<b>Title - Sujet</b> DND Workplace Furniture	
<b>Solicitation No. - N° de l'invitation</b> EB129-211701/A	<b>Amendment No. - N° modif.</b> 002
<b>Client Reference No. - N° de référence du client</b> EB129-211701	<b>Date</b> 2021-01-13
<b>GETS Reference No. - N° de référence de SEAG</b> PW-\$XAQ-027-7534	
<b>File No. - N° de dossier</b> XAQ-0-43122 (027)	<b>CCC No./N° CCC - FMS No./N° VME</b>
<b>Solicitation Closes - L'invitation prend fin</b> <b>at - à 02:00 PM</b> Newfoundland Standard Time NST <b>on - le 2021-01-14</b> Heure Normale de Terre-Neuve HNT	
<b>F.O.B. - F.A.B.</b> <b>Plant-Usine:</b> <input type="checkbox"/> <b>Destination:</b> <input checked="" type="checkbox"/> <b>Other-Autre:</b> <input type="checkbox"/>	
<b>Address Enquiries to: - Adresser toutes questions à:</b> Walsh, Heather	<b>Buyer Id - Id de l'acheteur</b> xaq027
<b>Telephone No. - N° de téléphone</b> (709) 631-1853 ( )	<b>FAX No. - N° de FAX</b> ( ) -

## CONTRACT AMENDMENT 002

### Questions and Answers:

Q1: Re CAT6B NSA line # 42

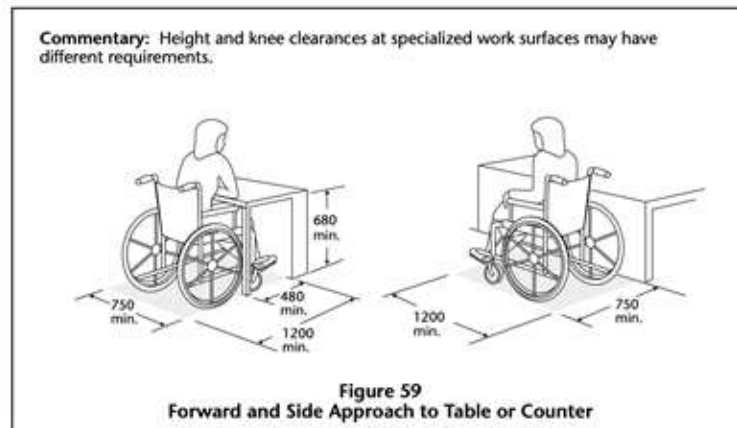
- a) would an all laminate panel system application that carries power/data through a base raceway be acceptable as long as power/data can be carried up to the worksurface.

- b) ADA defines an accessible table has a surface height of no more than 34 inches and no less than 28 inches above the floor. A wheelchair will fit with a clearance of 28"H, would this be acceptable given the total width of the accessible surface is barrier free to fit a wheelchair?

PSPC Response: And all laminate product that carries power/data through a base raceway is acceptable as long as wire management systems is provided to carry power and data to the desktop to ensure cables are easily accessible and tight to the systems to ensure clear space under the desk for the end user.

PSPC Response: The CAN/CSA B651-18 standard states a 680 mm min distance from the floor to the underside of the counter. The countertop must be in the range of 810-860mm high from the floor. These requirements must be met to be acceptable.
